Town of Franklin

Planning Board

June 1, 2020

HENNEP CULTIVATION & PRODUCTION FACILITY

FIELD CHANGE PLAN
"MINE BROOK ESTATES"
FRANKLIN MASSACHUSETTS

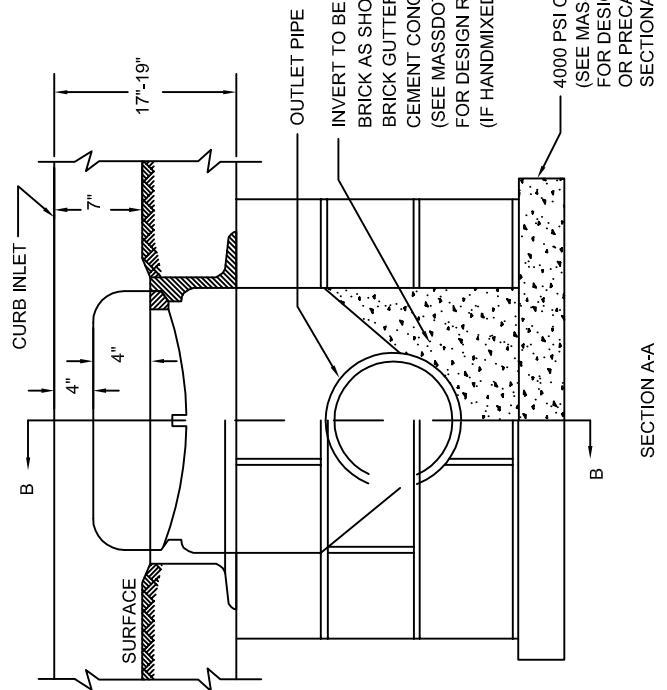
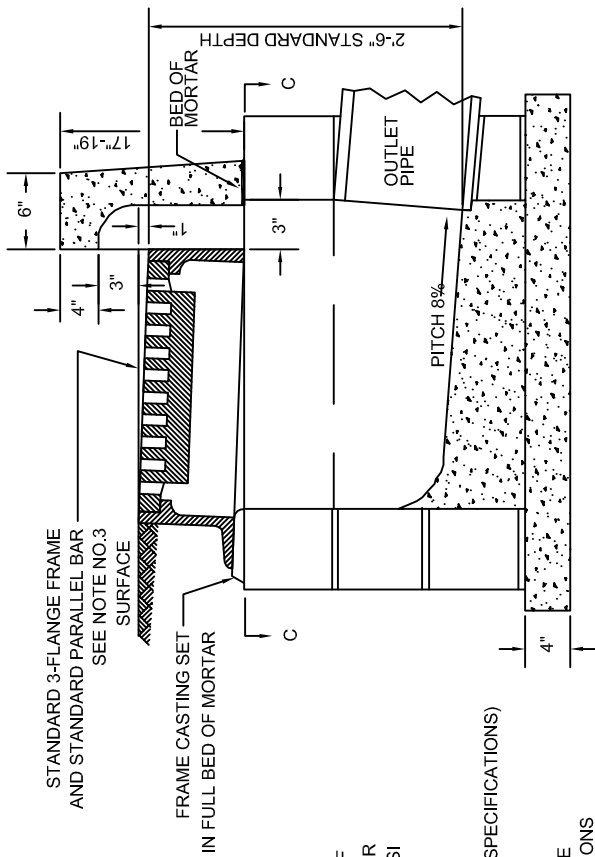
Please find attached the proposed field change that we respectfully request to discuss with the Planning Board under General Business at the next available Planning Board meeting for the above referenced project. As depicted on the attached drawing, we are proposing to construct a 20'+/- boulder wall to allow for a smooth transition between the existing and finished ground elevations. The boulder wall is approximately 1.5'-2' in height and the contractor will maintain a 3:1 slope from the back of the walk to the property line. Evergreen ground cover for further stabilization will be installed. In addition, this field change would require the existing catch basin grate to be replaced with a manhole cover and fitted with a gutter inlet (attached).

FLARED END EROSION PROTECTION DETAIL
(not to scale)

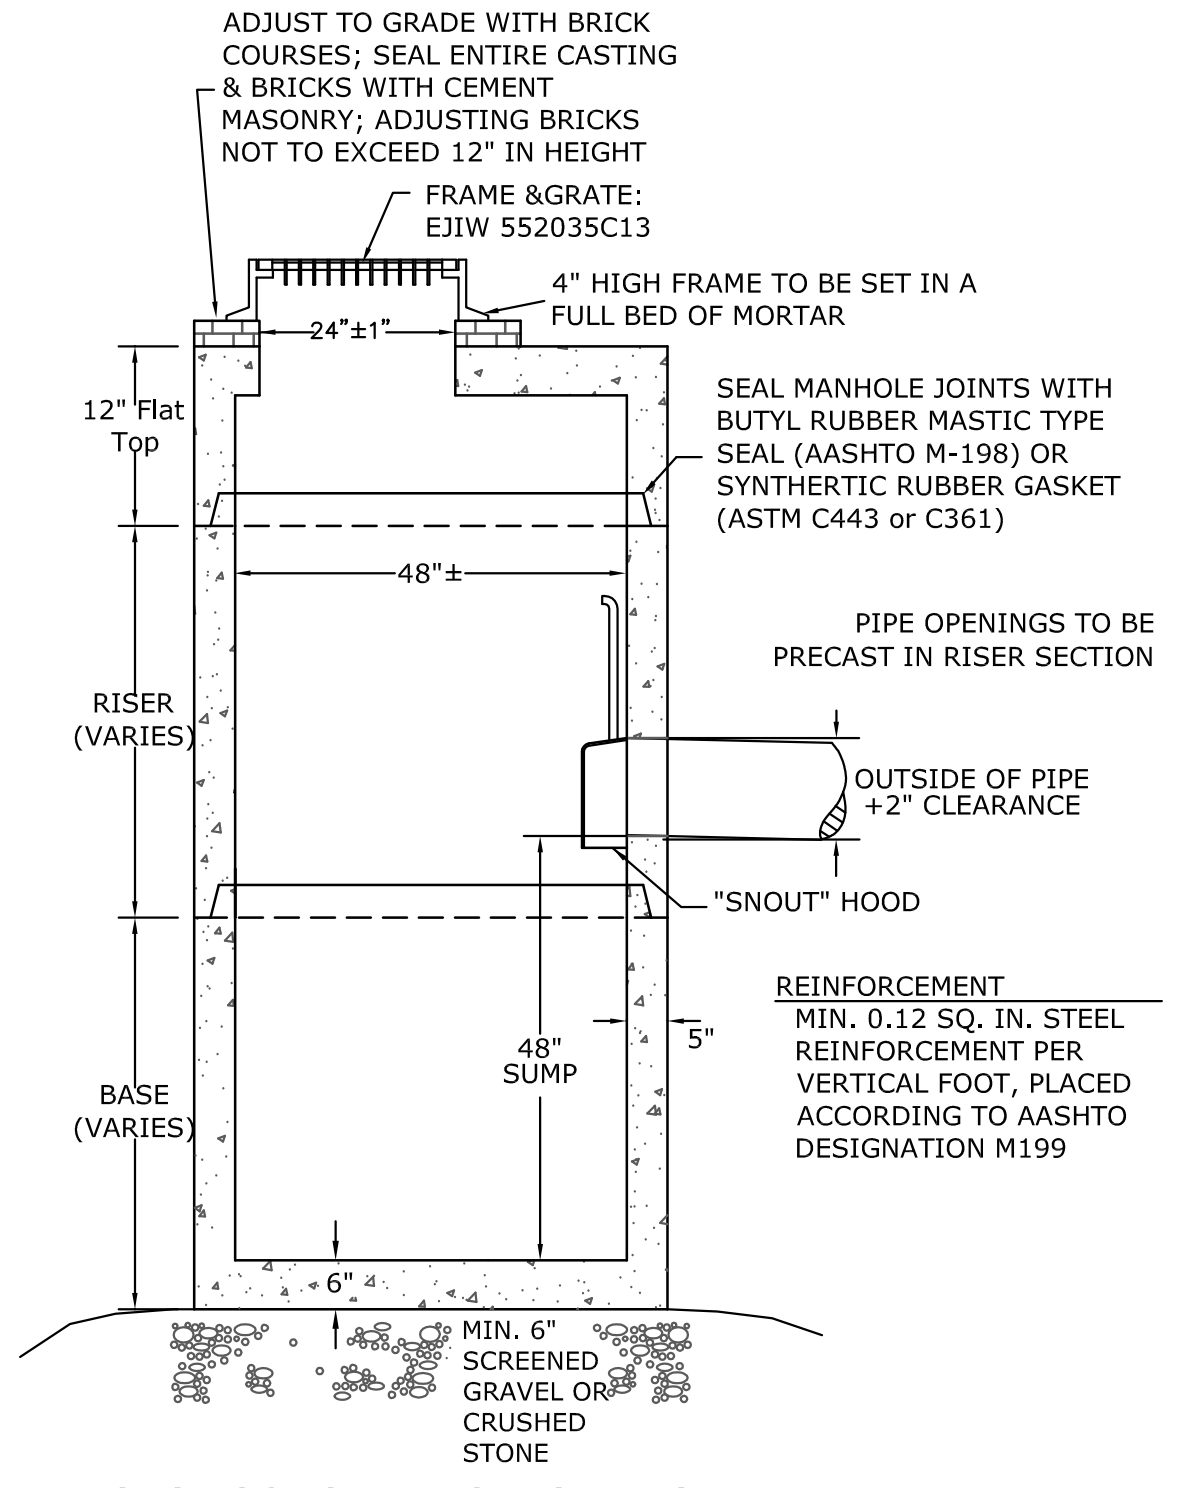
SW3. Revise dimension table on Flared End Erosion Protection Detail to match rip rap apron sizing calculations in the Stormwater Report. *LPI: The table on sheet 13 has been revised to match the calculations within the Stormwater Report.* **BETA2: Table revised – issue resolved.**

The table on sheet 13 has been revised to match the calculations within the Stormwater Report.

STORMWATER BASIN CROSS SECTION
(not to scale)

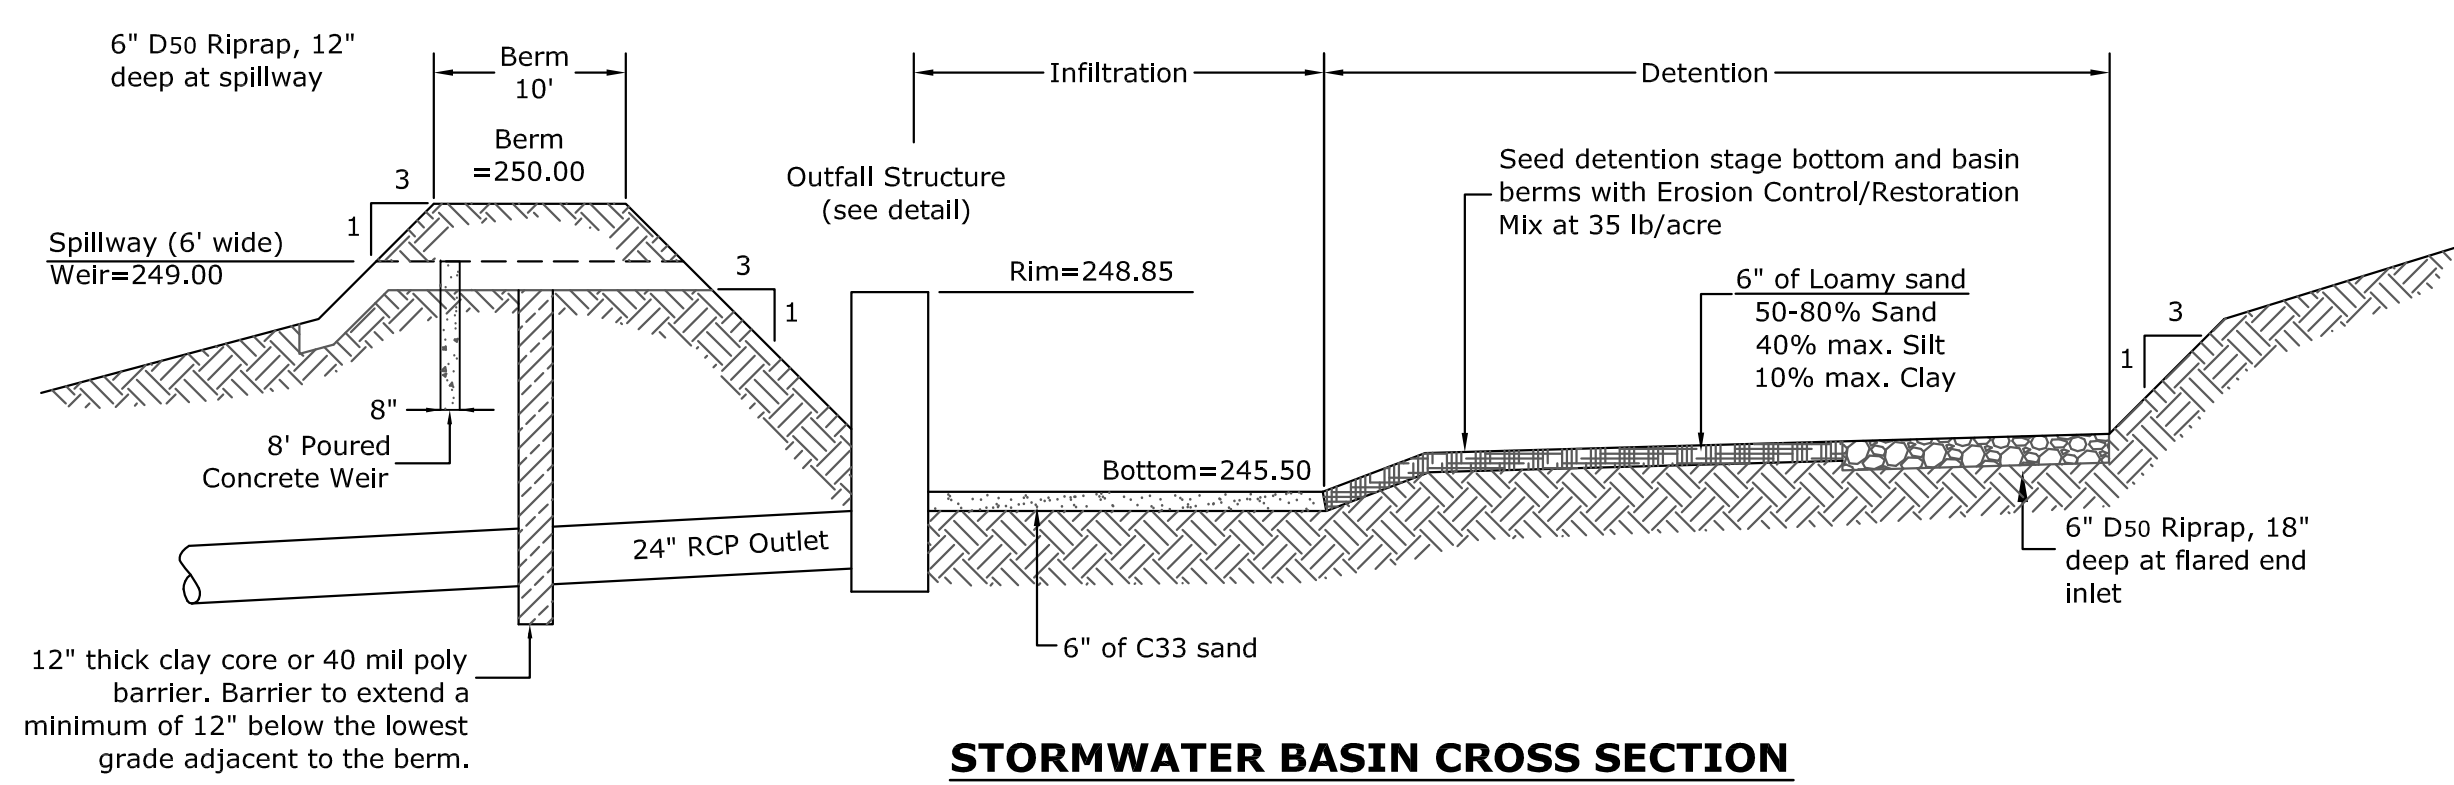
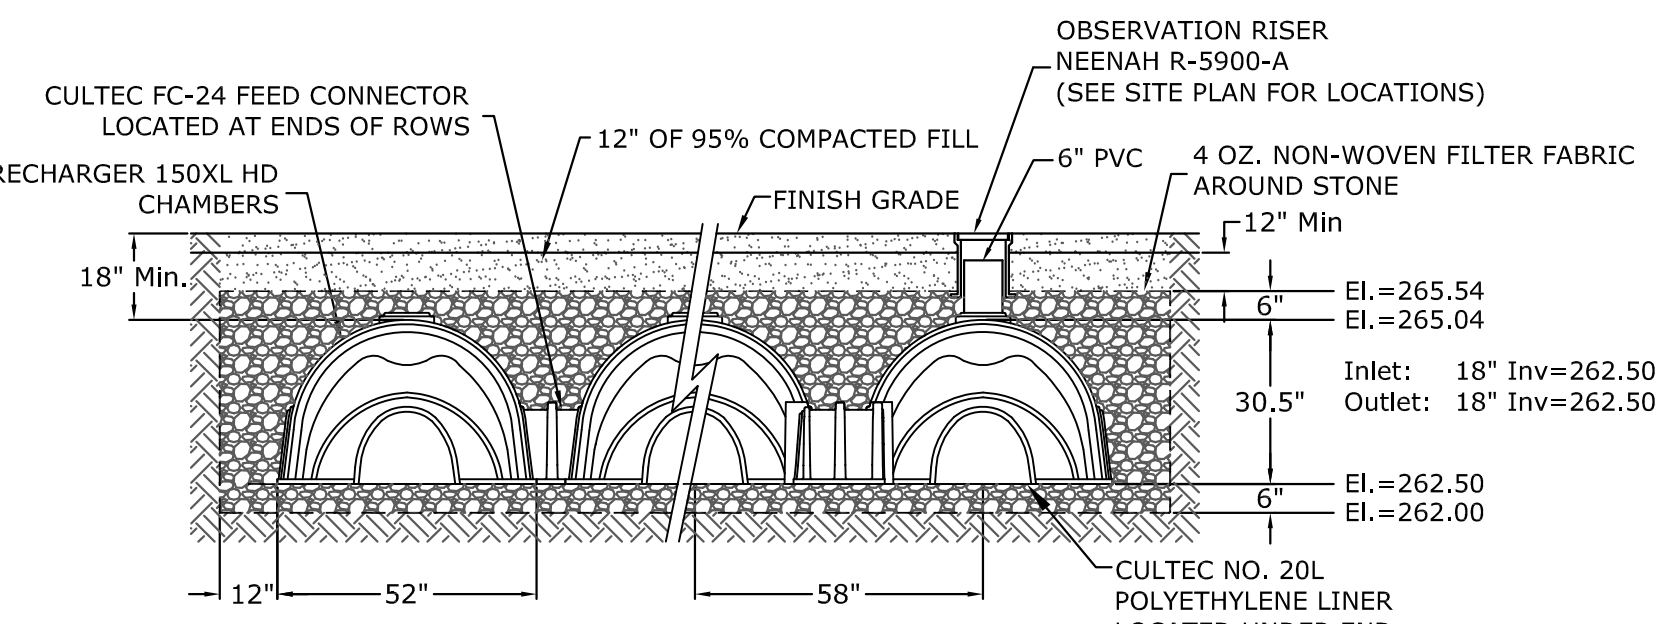
SW12. Specify soil media to be applied to the stormwater basin. Typical loam and turf grass is likely to restrict the infiltration potential of the basin. Consider a special loamy sand mixture with 50% sand and a restoration seed mixture. *LPI: The soil media for the stormwater basin has been added to the basin cross section on sheet 13, Details Plan. BETA2: Loamy sand mixture proposed – issue resolved.*

The soil media for the stormwater basin has been added to the basin cross section on sheet 13, Details Plan.

SIGN DETAILS
(not to scale)

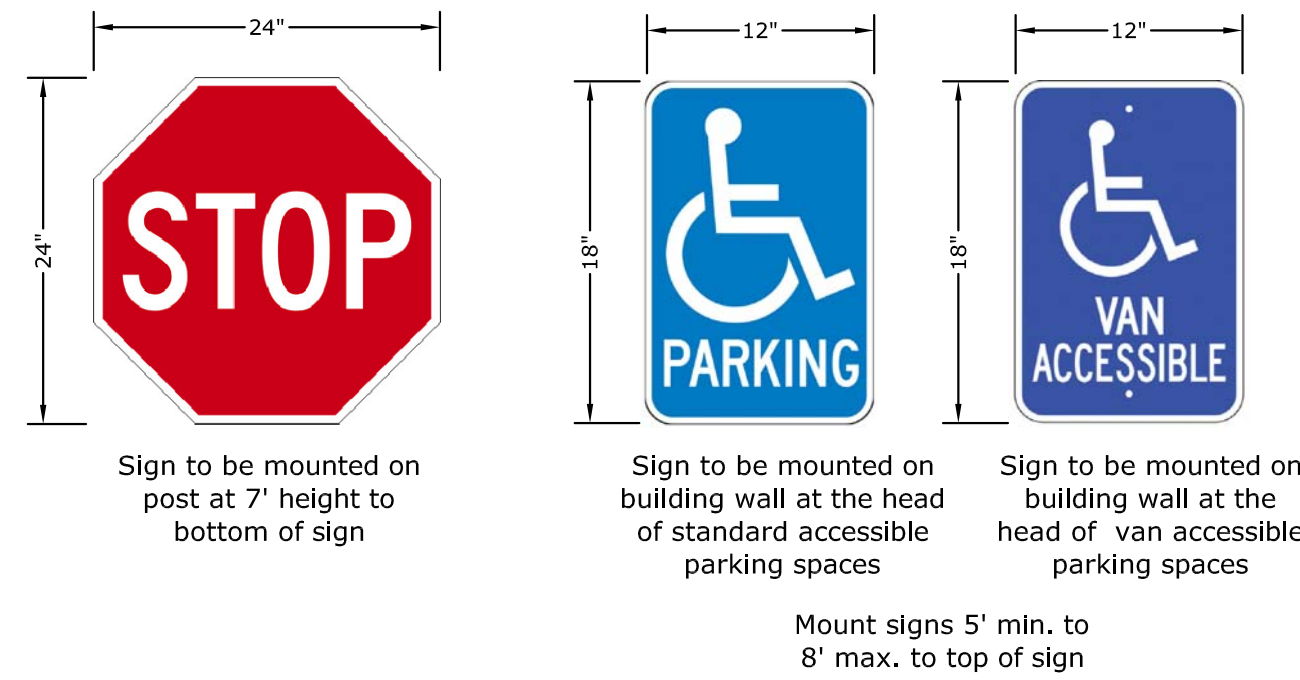
- P9. Revise accessible parking spaces to include handicap parking designations and signs in conformance with MAAB requirements. *PLT: Sign details/requirements will be added to the next plan revision. BETA2: Issue remains outstanding. LPI: Notes regarding the required accessible parking signage has been added to the plan. Details of the signs have been added to sheet 15, Details Plan. BETA3: Accessible signing and striping provided – issue resolved.*

Notes regarding the required accessible parking signage has been added to the plan. Details of the signs have been added to sheet 15, Details Plan.

RETAINING WALL #1
SOUTH/EAST ELEVATION PROFILE
Horizontal Scale: 1" = 40'
Vertical Scale: 1" = 4'

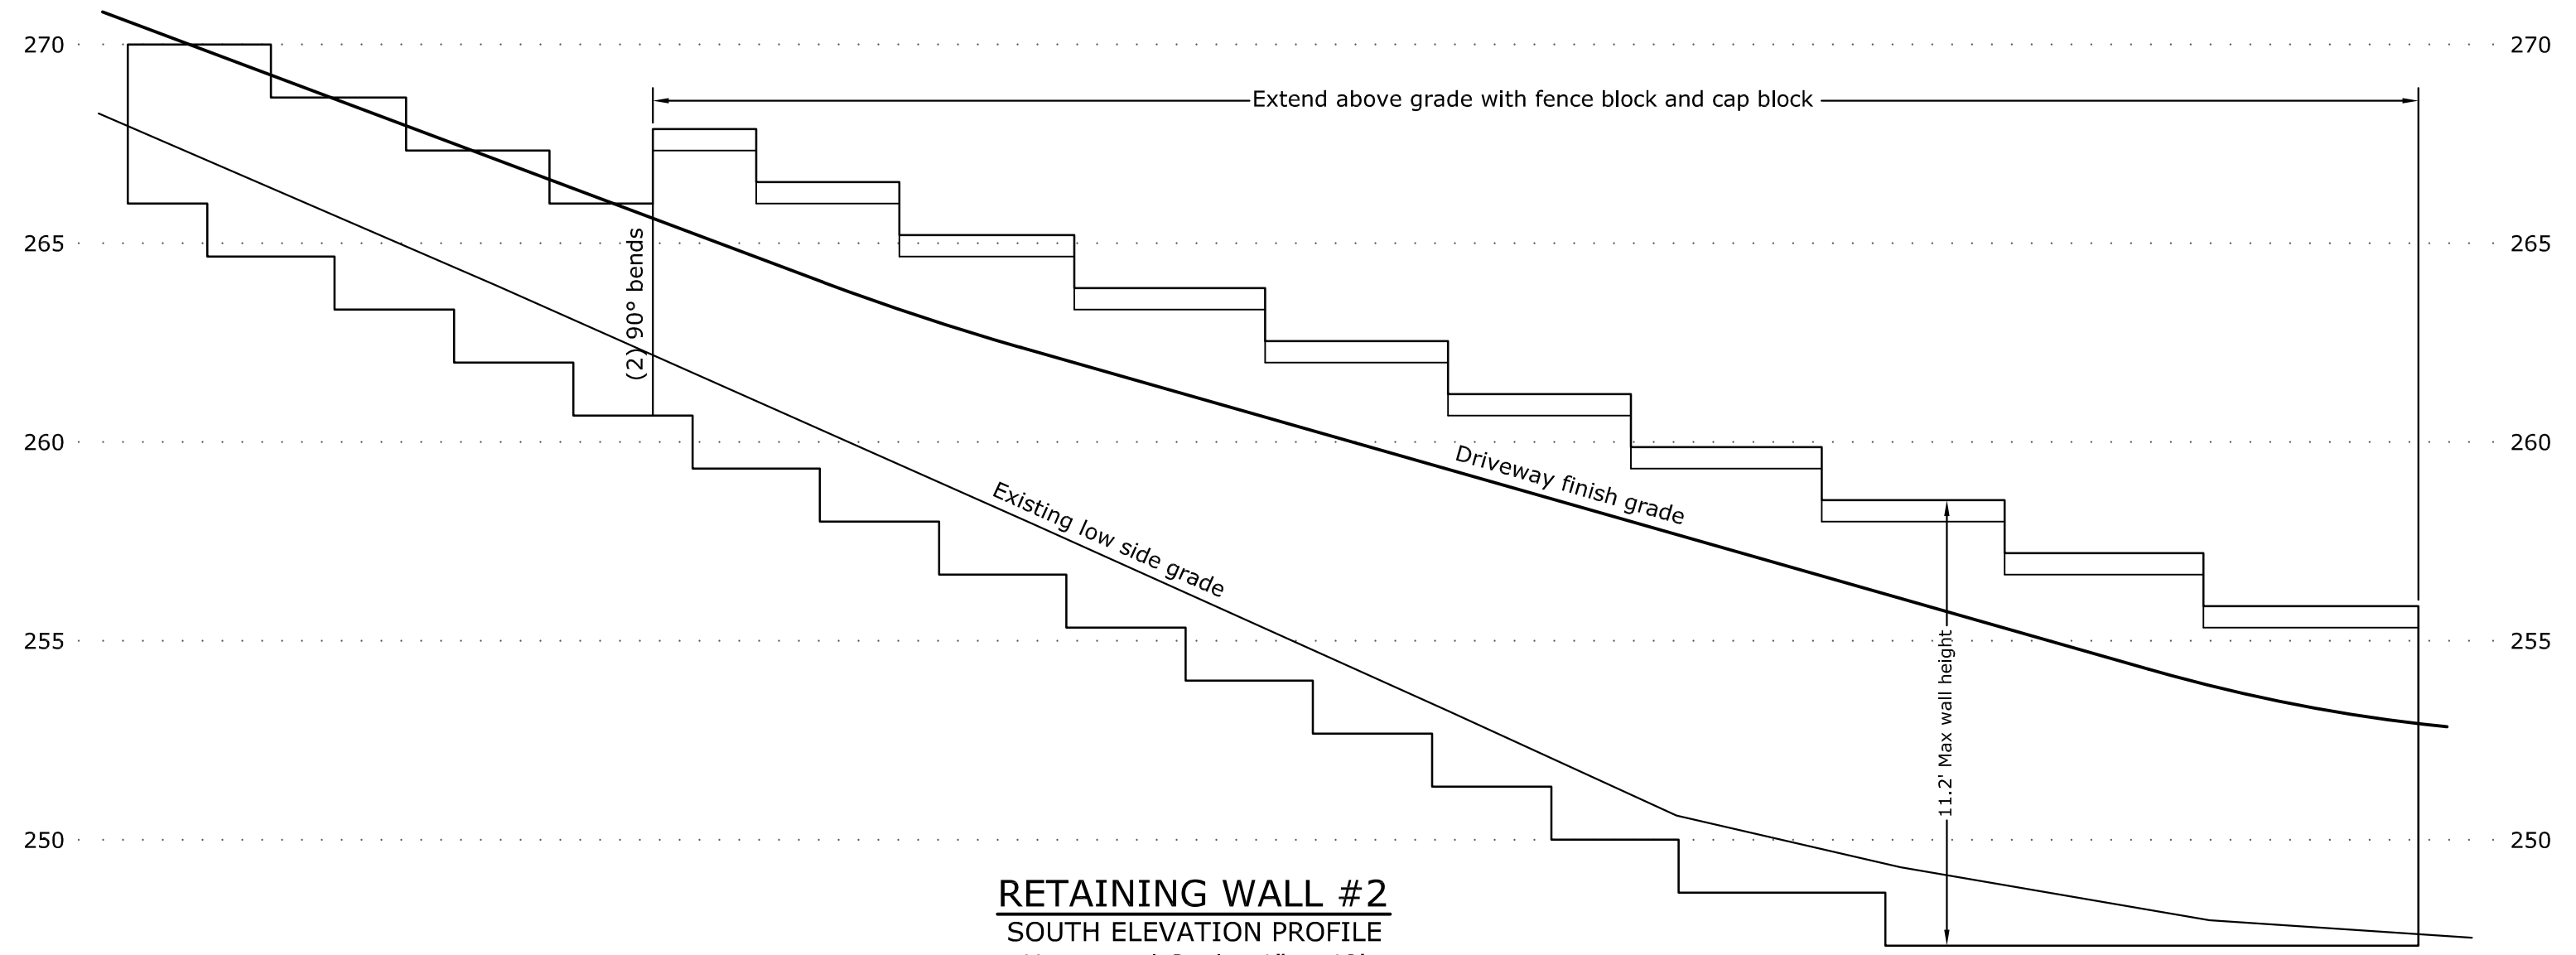
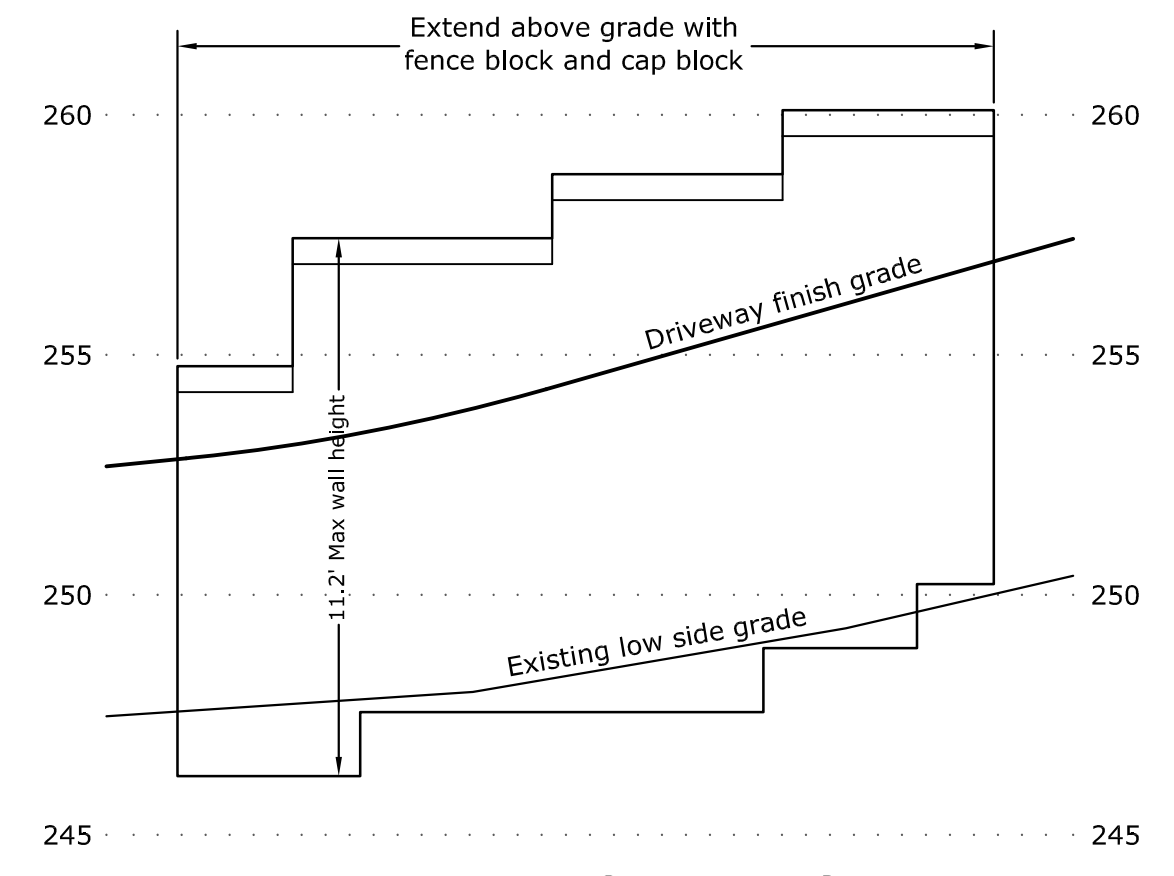
elevations of the 3 proposed retaining walls have been added to sheet 16 of the plans. The specifics of the structural design and details will be provided by others as part of the building permit application for the retaining walls. BETA3: Information provided. BETA notes that due to height of the walls (>10 feet) structural design and permitting through the building department will be required prior to construction.

General details and elevations of the 3 proposed retaining walls have been added to sheet 16 of the plans. The specifics of the structural design and details will be provided by others as part of the building permit application for the retaining walls.
